UNITED STATES PATENT AND TRADEMARK OFFICE

10/781,775

Office Action Summary	Application No. 10/781,775	Applicant(s) HARRIS ET AL.	
	Examiner QUYNH-NHU H. VU	Art Unit 3763

DETAILED ACTION

**FIG. 7**

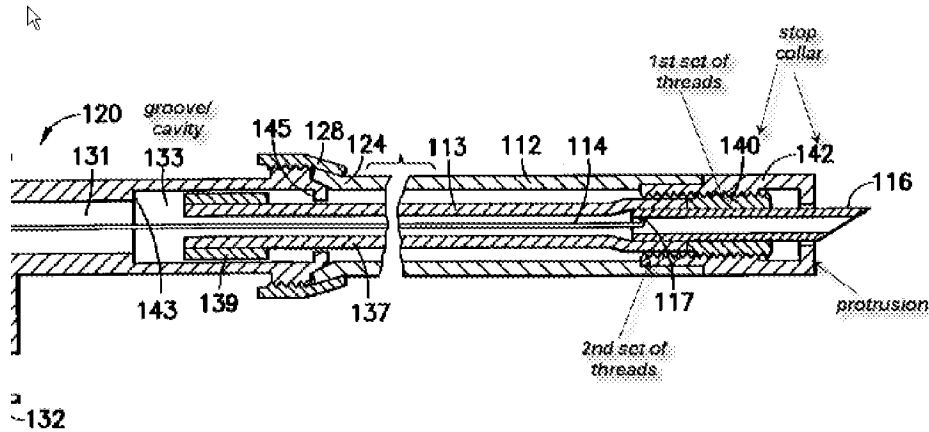
Smith discloses an injection catheter comprising: a first elongated shaft 112 having a distal end and a proximal end and a first lumen extending there between;

a needle 116 with a proximal end and distal end and a needle lumen extending there between, the needle disposed within the first lumen of the first elongated shaft and extending from a proximal end of the catheter to a distal end of the catheter;

a stop collar 140, 142 disposed within the first lumen of the first elongated shaft near the distal end of the needle; the stop collar having a protrusion portion thereon configured to prevent lateral movement of the stop collar within the first elongated shaft (see Fig. 7 below);

a first set of threads of element 140 located on the needle;

and a second set of threads located on the stop collar 142; wherein rotation of the needle within the first elongated shaft causes longitudinal movement of the stop collar relative to the needle within the first elongated shaft, the positioning of the stop collar within the first elongated shaft controlling a variable extent to which the needle may be extended beyond the distal end of the first elongated shaft.

As noted that, Applicant discloses in Fig. 3 that the needle having a first set of thread 339. However, Applicant discloses in claim 1 that a first set of threads located on the needle can be interpreted two ways: a) the needle having a thread set formed within needle wall or b) an element having thread set located on the needle. With the broadest interpretation, the needle sleeve/stop collar having a thread set and located on the needle can be read the limitation above. Beside that, the needle having thread set formed within the needle wall is very well-known in the needle art. Pshenichny et al. (US 3,750,667) is one of the examples that needle having a thread formed within the needle wall.

Regarding claim 4, wherein the portion of the stop collar configured to prevent lateral movement comprises: a plurality of outwardly extending longitudinal protrusions located on the stop collar; and a plurality of grooves 133 in an inner surface of the first elongated shaft to slidably receive the plurality of outwardly extending longitudinal protrusions, col. 8, ll.35-39.
